**TOWN OF MANCHESTER  
PLANNING AND ZONING COMMISSION**

**RE:** Hari Kuppuraj – 30 Bidwell Street  
PRD Zone Change – Preliminary Site Plan (PRD-0006-2022)

The applicant is requesting approval of a preliminary site development plan and a zone change from Rural Residence to Planned Residential Development (PRD) zone at 30 Bidwell Street.

# Proposed Site Plan

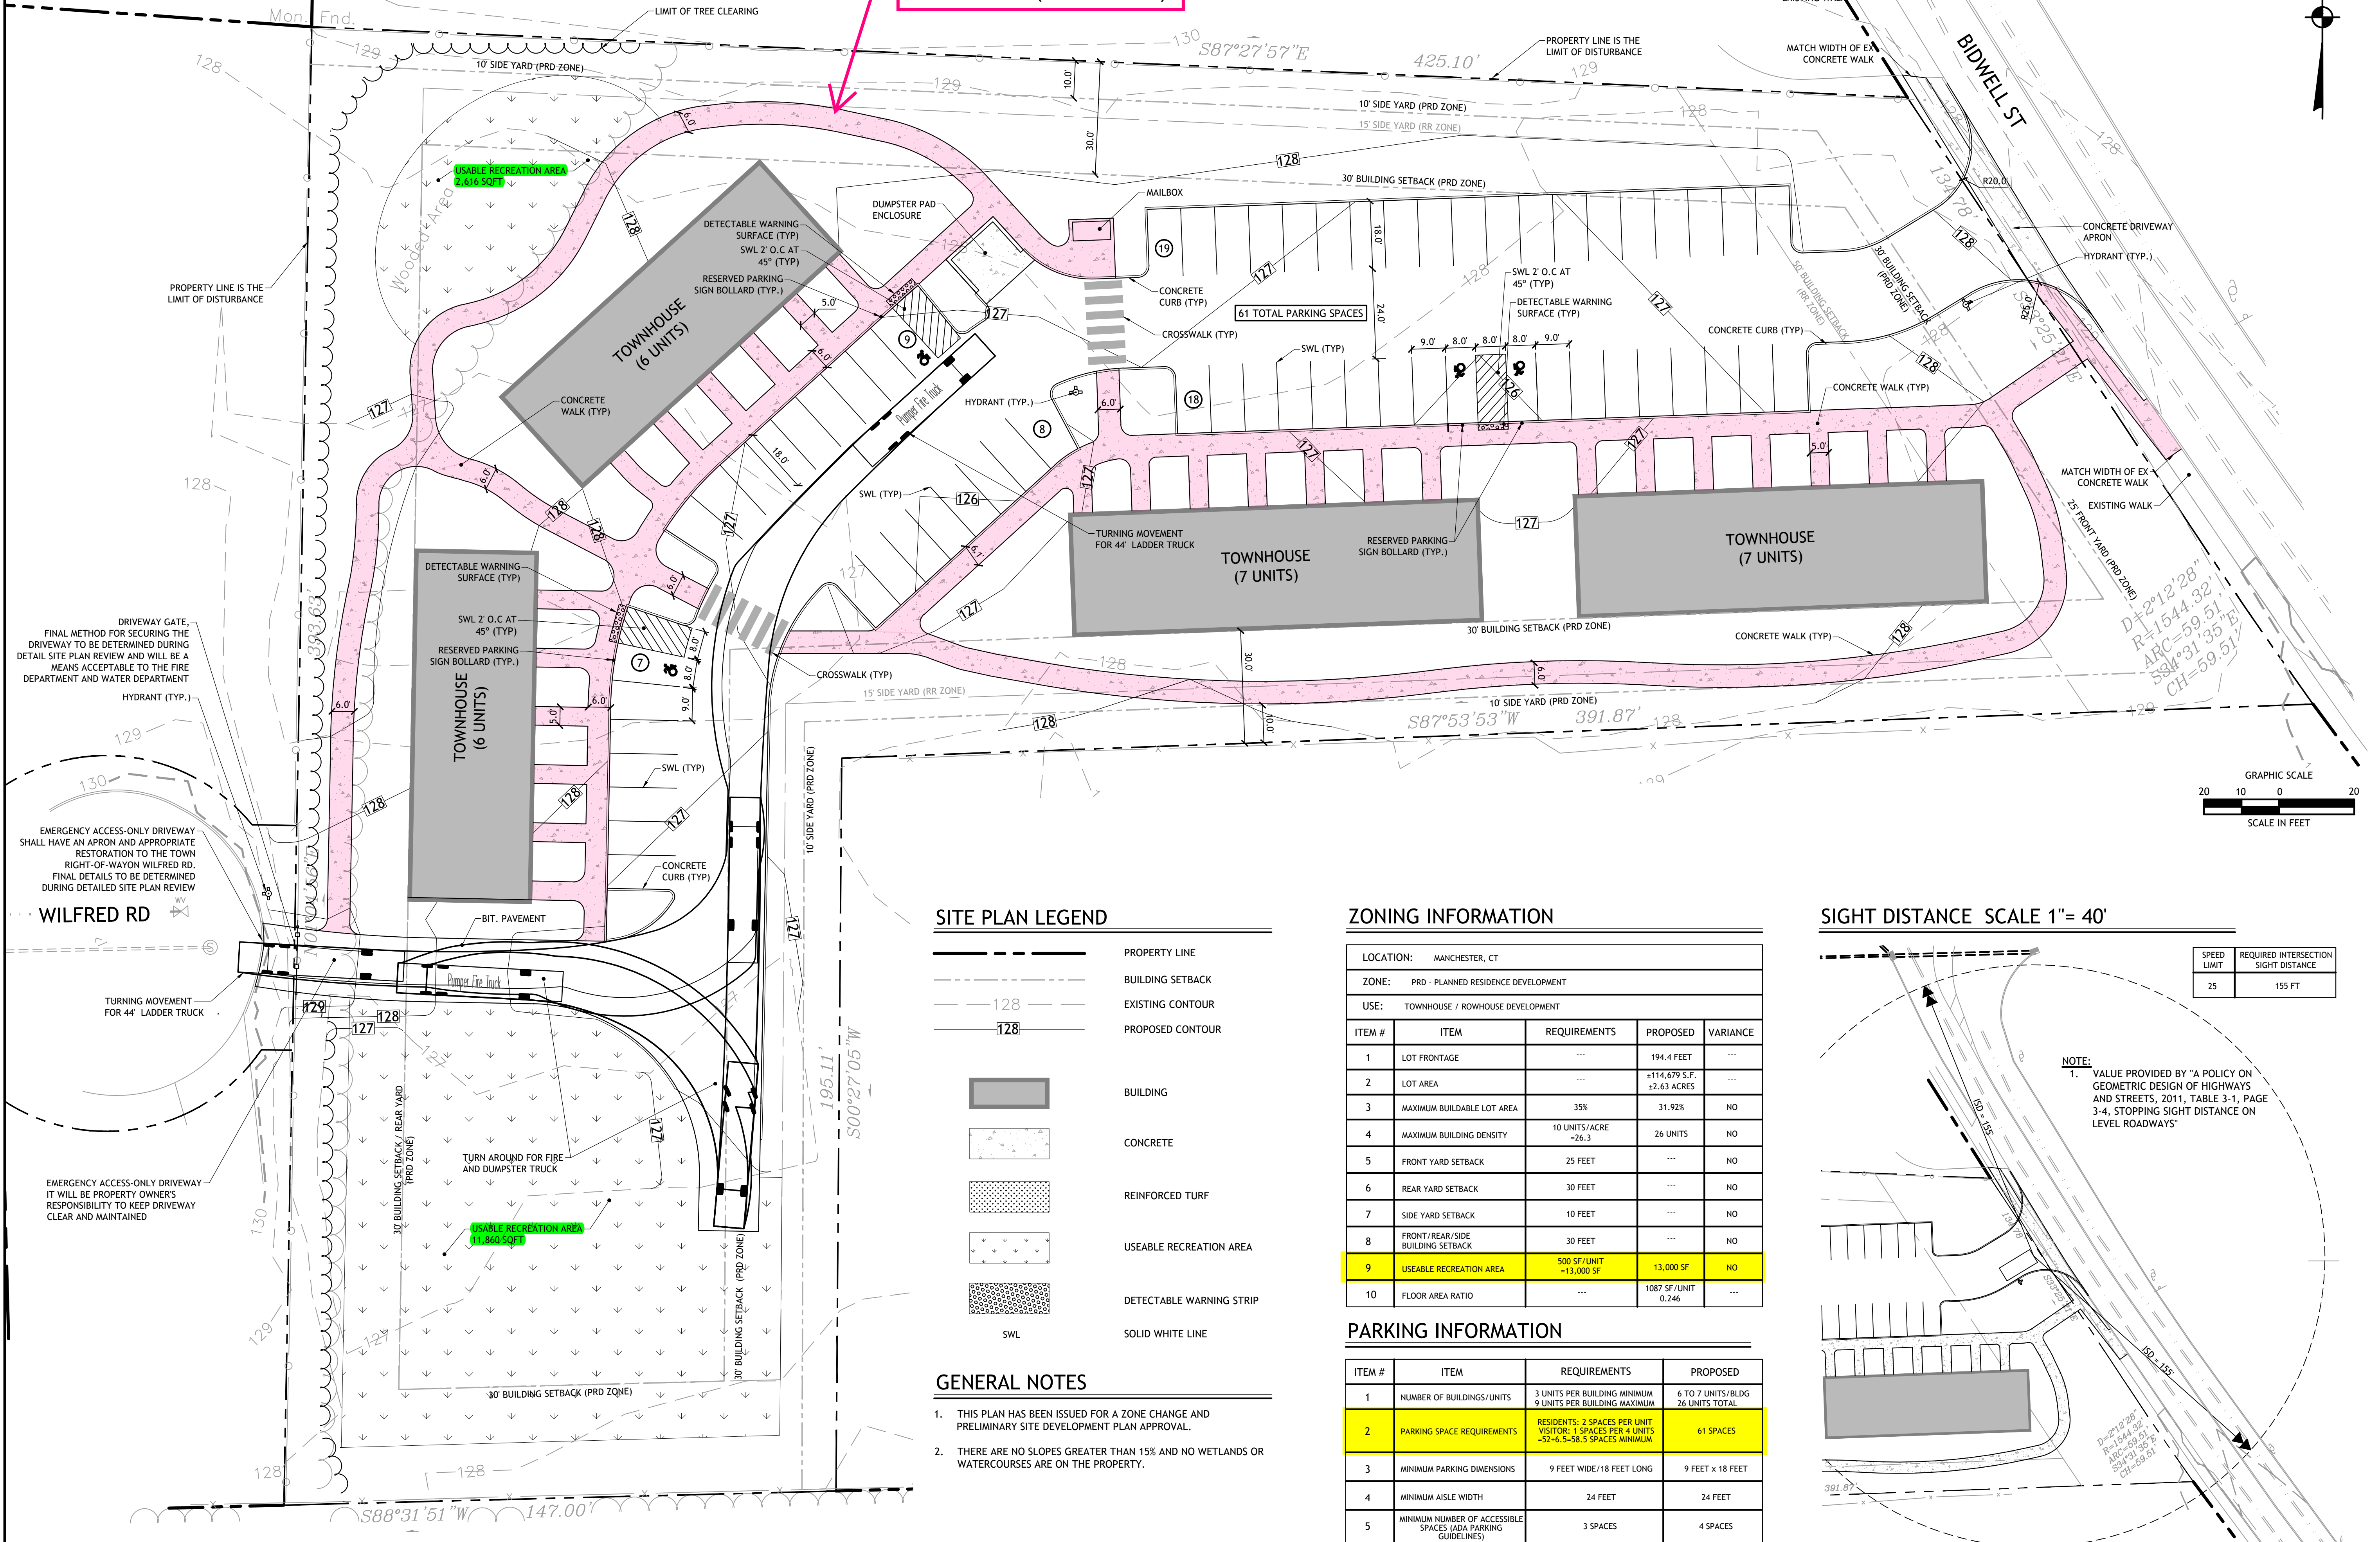
Multi-family residential developments in the PRD zone are required to provide usable outdoor recreation area for residents at a ratio of 500 sq. ft. per dwelling unit. With 26 units proposed, a minimum of 13,000 sq. ft. of recreation area is required.

The proposed site plan shows a large (12,273 sq. ft.) recreation area on the southern end of the site, and a smaller (2,616 sq. ft.) area in the northwest corner of the site behind one of the proposed buildings. Both of these areas are accessible to pedestrians via the proposed concrete sidewalk network.

Staff asked the applicant to consider a connection between the Town-owned park at the end of Wilfred Road and the recreation area within the proposed development. The applicant has indicated that they prefer not to provide this connection.

**TITLE: DRAINAGE & UTILITY PLAN**

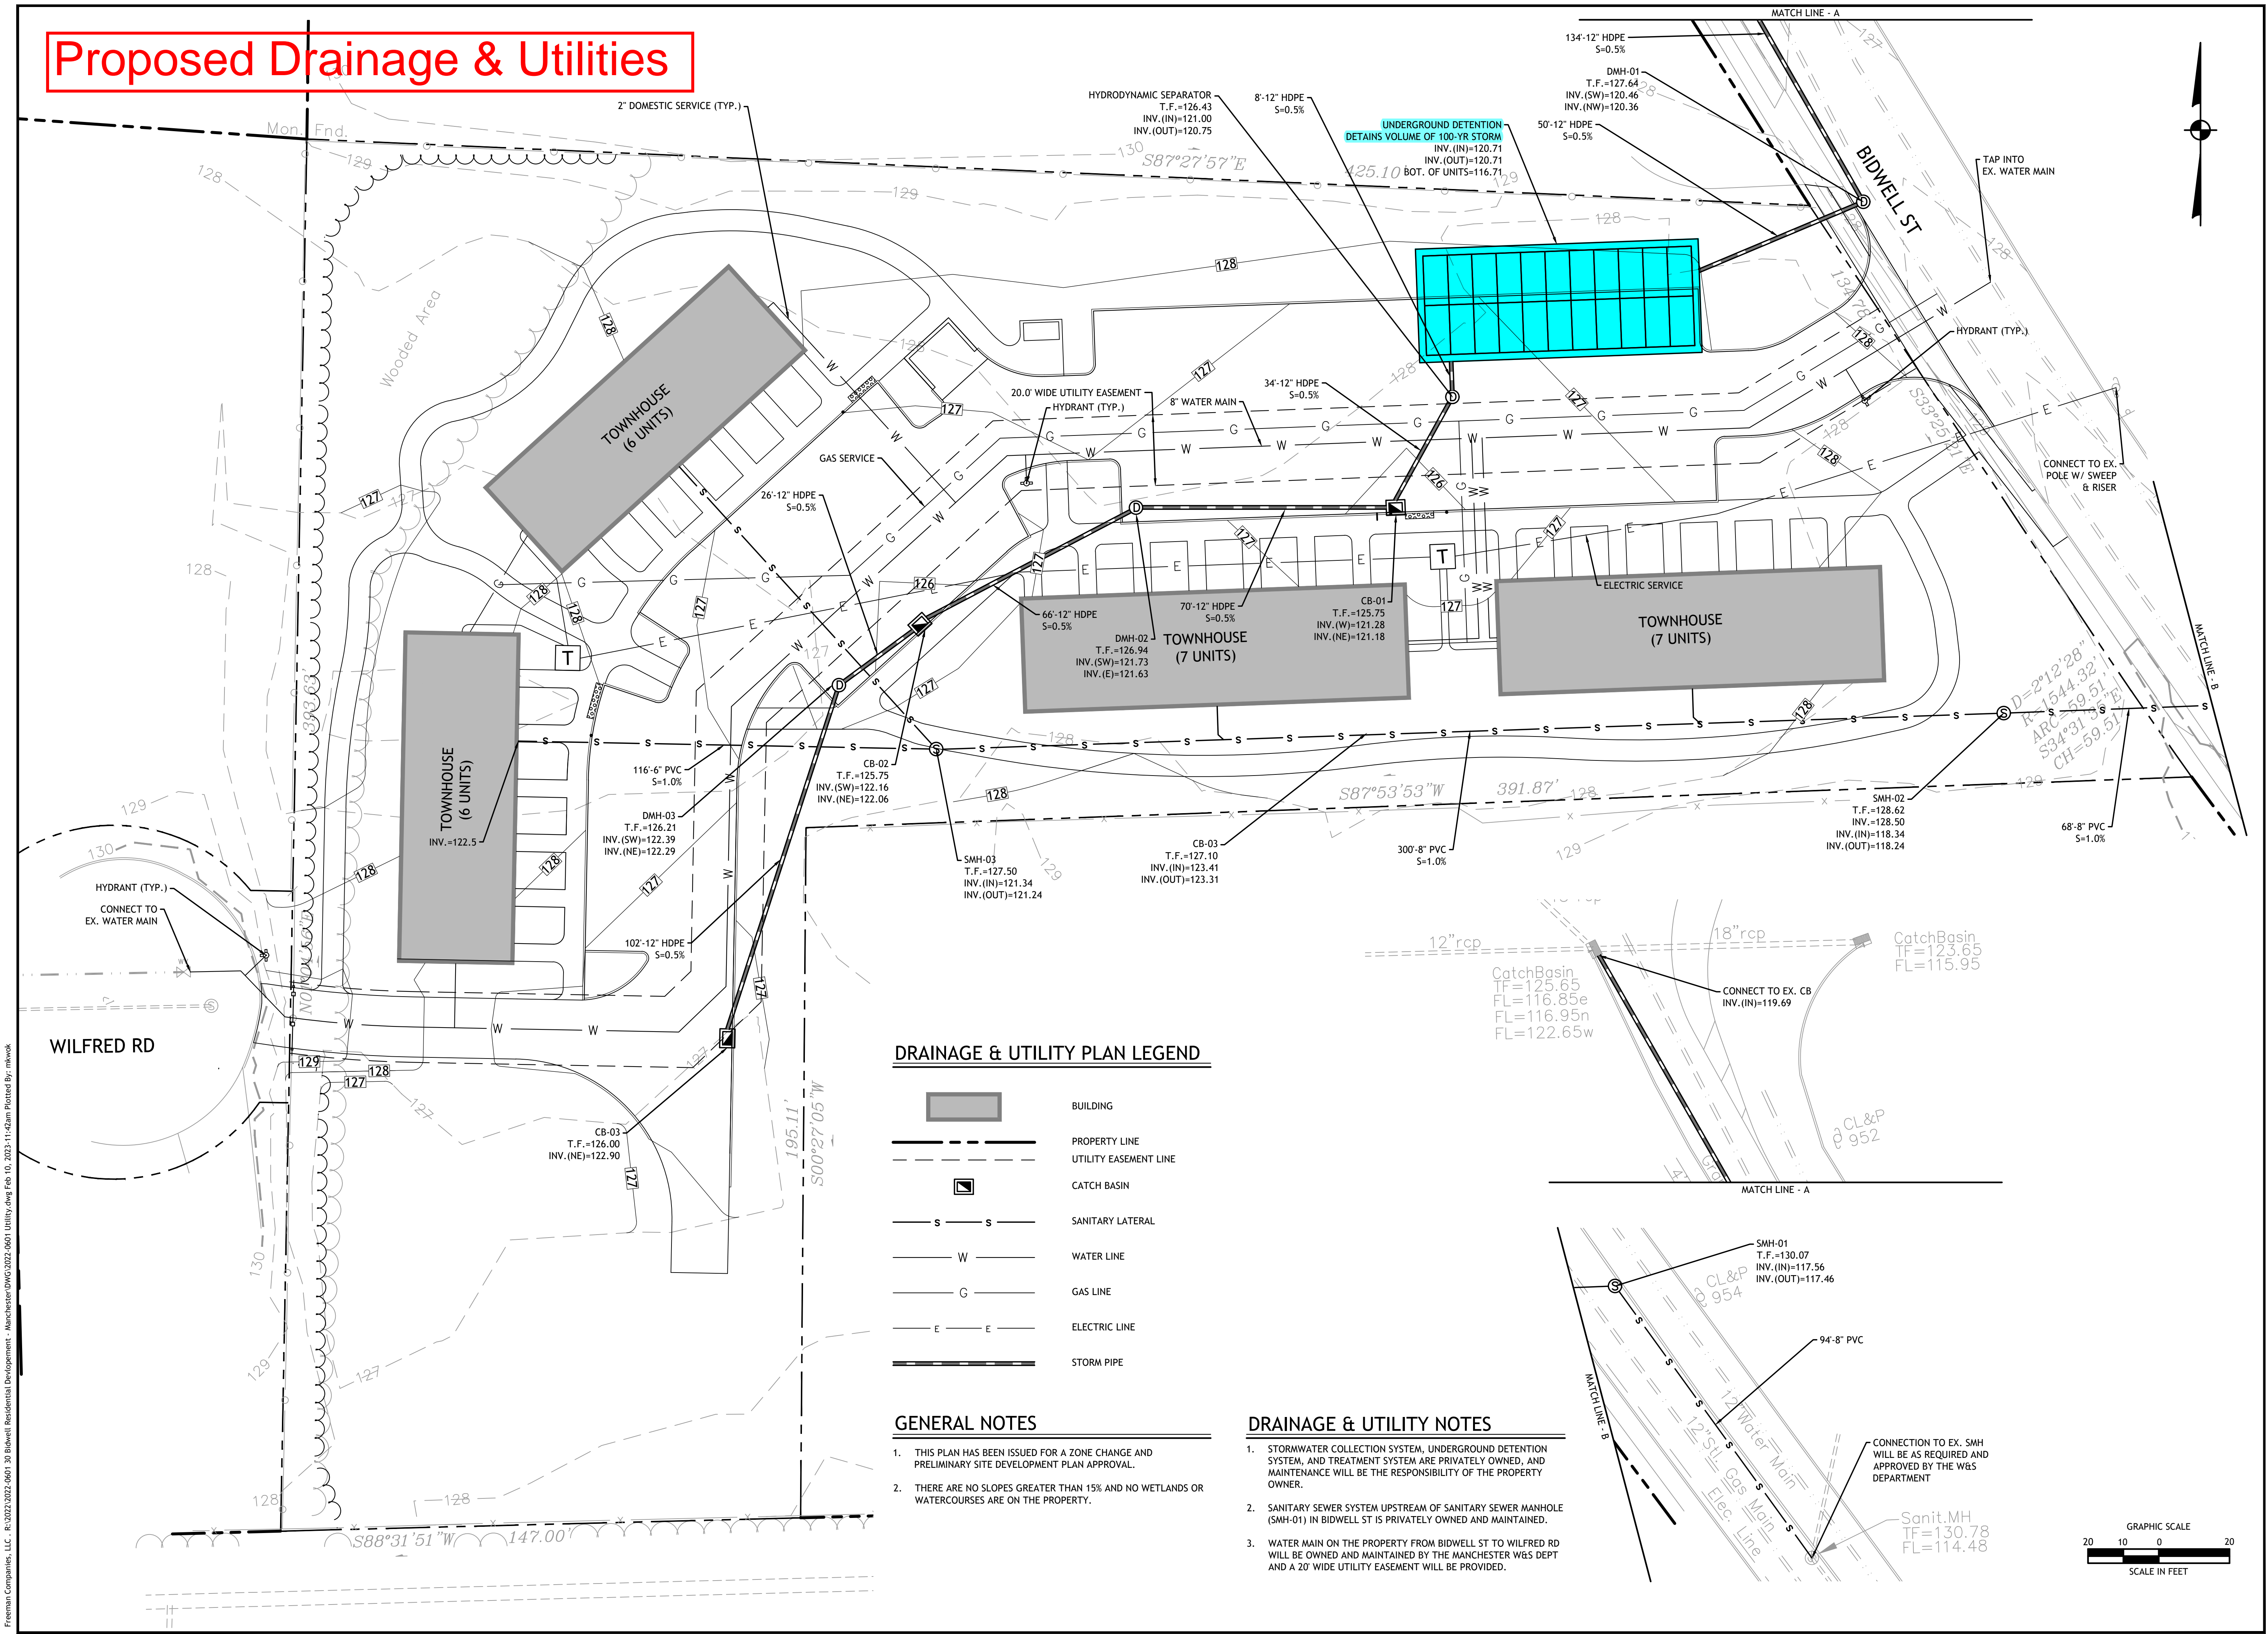
The proposed stormwater management system includes catch basins in the paved parking lot, which will be connected by a subsurface pipe network discharging to an underground detention system (highlighted in blue on sheet C1.02 of the attached plan set). Stormwater will pass through a hydrodynamic separator for filtration before entering the detention chamber, and will leave the site via a new pipe under Bidwell Street which will connect to the existing stormwater system to the north.

The applicant originally proposed a series of rain gardens for on-site infiltration of stormwater instead of the underground detention system. However, staff advised against this due to the proximity of the proposed rain gardens to underground utility lines. It would not be feasible to provide sufficient depth for stormwater storage due to the depth of the utility lines, and planted rain gardens would likely be negatively impacted by winter salting due to the proximity to the pavement.
